NO: MS-022 **PRODUCT:** ZJ-BAS-PS01 Ionizer
DATE: November 2015 **TYPE:** Modification Notice

AC Adapter ZJ-BAS-PS01 for Digital Bar Type Ionizer will Change Due to Supplier Discontinuation

Changes

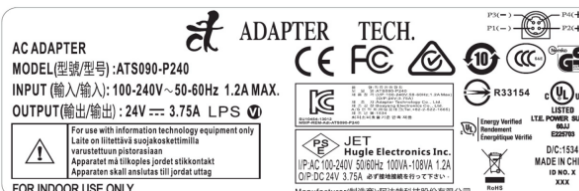
Reason for Modification: The dimensions and appearance of the AC adapter will change when we change suppliers for this part. The inlet and outlet shape of the new adapter is more familiar to international users.

Before the change	After the change
Outside dimension of AC adapter 139mm x 61mm x 36mm	Outside dimension of AC adapter 151mm x 64mm x 36mm

Before the change	After the change
Weight of AC adapter 430g	Weight of AC adapter 475g

Before the change	After the change
<p>Contents of label of AC adapter</p>  <p>(Background: White, Character: Black)</p>	<p>Contents of label of AC adapter</p>  <p>(Background: Black, Character: Silver) full-fledged revision</p> <p>* No change about electrical specification, for example Input/Output voltage and current capacity and so on.</p>

Before the change		After the change	
Outside dimension of Inlet and outlet between AC adapter and AC cable.		Outside dimension of Inlet and outlet between AC adapter and AC cable.	
Outlet type of AC cable	Type C5	Outlet type of AC cable	Type C13
Inlet type of AC adapter	Type C6	Inlet type of AC adapter	Type C14
Outside dimension		Outside dimension
